SUBJECT: SAFETY RECALL: FRONT AXLE BRAKE HOSE ROUTING

Ref.: **NHTSA # 15V-001**

Service Bulletin No. 420

MODEL	J4500 Series	TYPE	Field Change Program	SECTION/GROUP	1-Front Axle	DATE	March 2, 2015
SUBJECT	FRONT AXLE BRAKE HOSE ROUTING						
CONDITIONS

Figure 16.

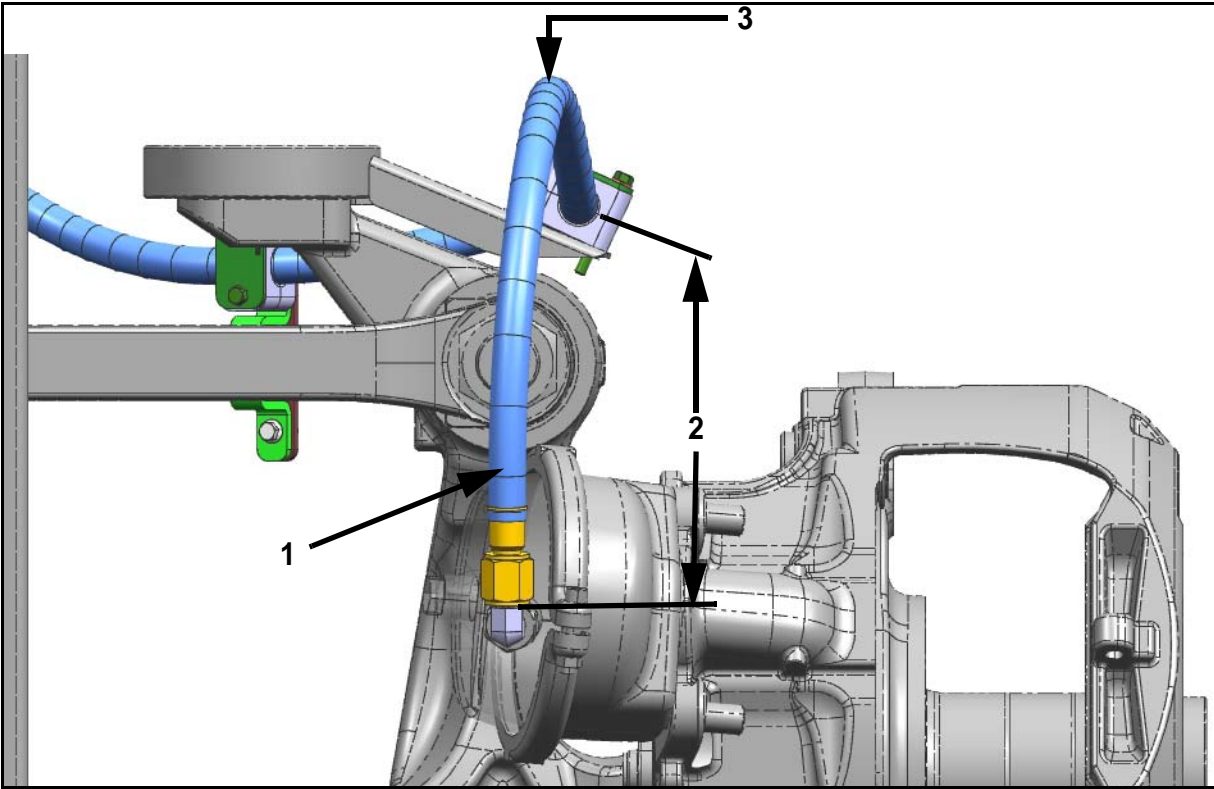
42. Using a measuring tape, ensure that the front brake hose length is the 22.00 inches between the bottom of the swivel fitting to the inside face of the clamp as shown in Figure 16. Tighten clamp to secure in position.

Item	Figure 16 Description
1	front brake hose assembly, p/n 04-20-1726
2	22.00 inch of hose length from bottom of fitting to inside face of clamp
3	measurement to be taken along the top section of the front brake hose assembly

Figure 17.

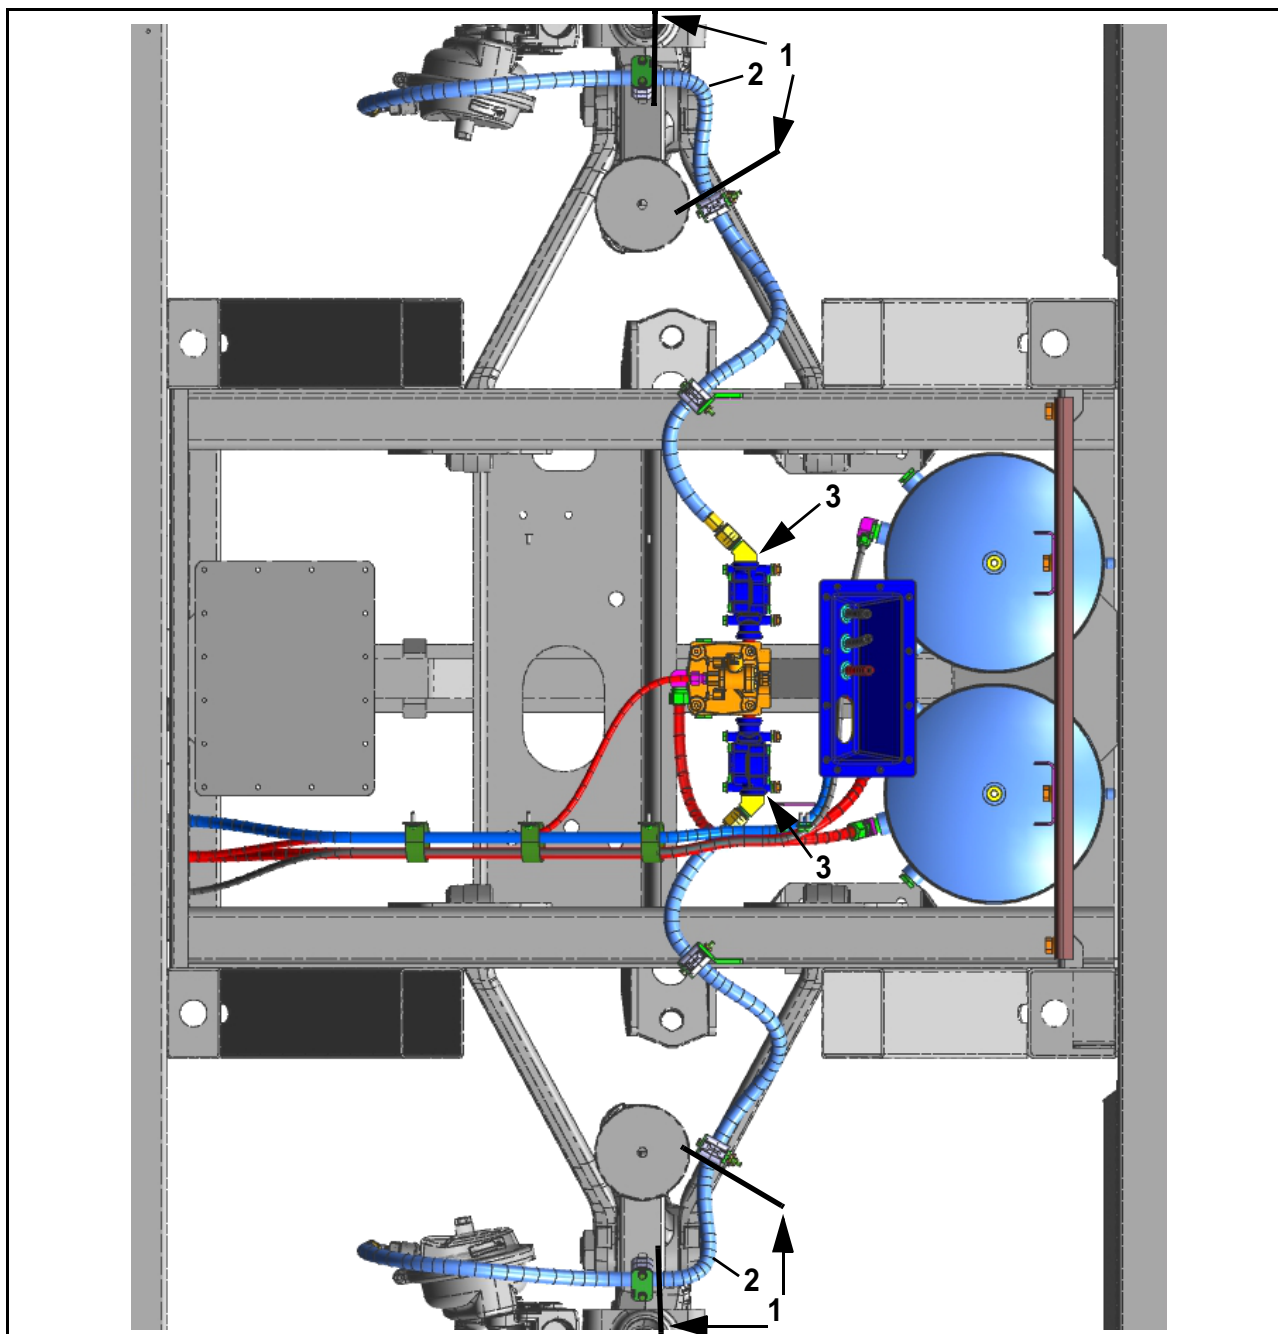
43. Route the front brake hose assembly to the next (second) brake hose bracket. Using the existing mounting hardware, mount the clamp assembly to the brake hose bracket.
44. Using a measuring tape, ensure that the front brake hose assembly routing length is the 8.00 to 8.25 inches of hose length from face to face of the clamps while maintaining a minimum bend radius of 2.25 inches as shown in Figure 17.
45. Tighten clamps to secure in position.

47. Route the front brake hose assembly to the next brake hose bracket. Tighten clamp to secure the front brake hose assembly in position (refer to Figure 17).
48. Orient and connect, using two (2) wrenches, the end of the brake hose assembly to the 45 degree fitting on the front brake module valve(refer to Figure 17). Torque to 56-60 ft-lbs.
49. Using tyrap, secure the ABS sensor to the front brake hose assembly.
50. Repeat steps to opposite side of coach.

Item	Figure 17 Description
1	8.00 to 8.25 inches of hose length from face to face of clamps
2	measurement to be taken along the outboard section of the front brake hose assembly
3	45 degree fitting on the front brake module valve

Figure 18.

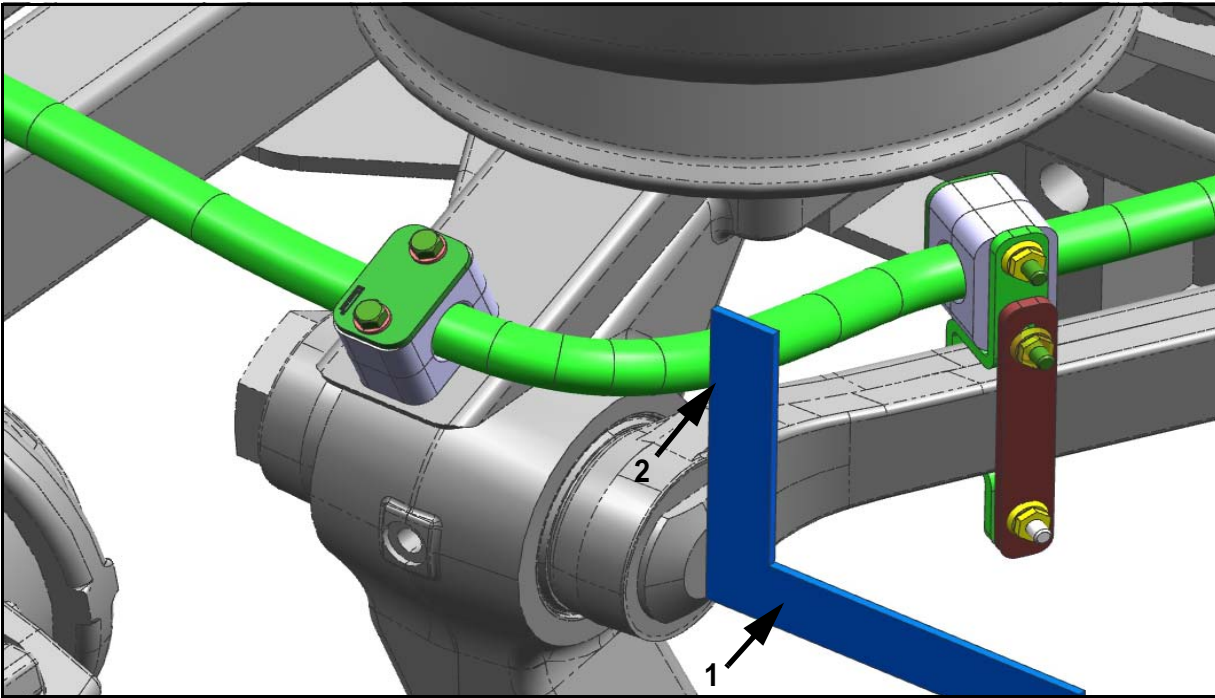
46. Position a square across the face of the suspension arm bolt head (refer to Figure 18). Using a measuring tape, ensure that there is a minimum clearance of 0.06 inch between the edge of the front brake hose assembly and the edge of the square.

Item	Figure 18 Description
1	position square across the face of the suspension arm bolt head
2	minimum clearance of 0.06 inch between the edge of the front brake hose assembly and the edge of the square
